Summary Notes from the River Plan / South Reach Open House -12/1/18, at Lewellyn School

Approximately 90 people attended the open house, which featured 5 display stations: 1) Project Overview and Urban Design Concept, 2) Recreation, Parks, Trails and Scenic Resources, 3) Natural Resources: Habitat, Vegetation and Floodplains, 4) Transportation; and 5) Land Use and Zoning. Each display station had a map(s), displayed information on what we've (project staff have) learned, draft plan concepts for zoning and other implementation actions, and a chart pack for people to share their comments. A couple of stations had Big Idea concept illustrations. They were the Natural Resources and Recreation display stations. Comment cards were also available for participants to provide their thoughts on the materials presented at the open house or anything else related to the South Reach.

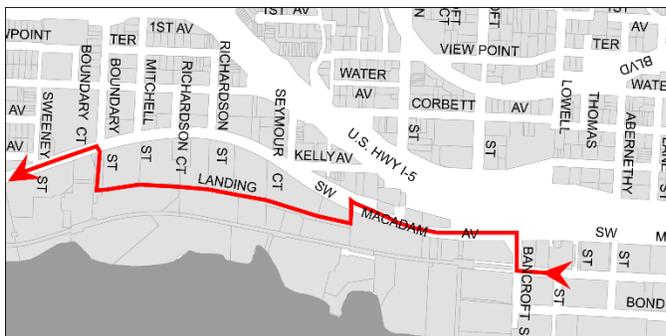
- Suggestion: Run streetcar from end of current line on Moody to Willamette Park (or further) not using the existing trolley tracks (super dangerous with pedestrians, dogs, etc. and no businesses), rather use the street (Macadam to Landing to Boundary to Macadam < **see map below**)
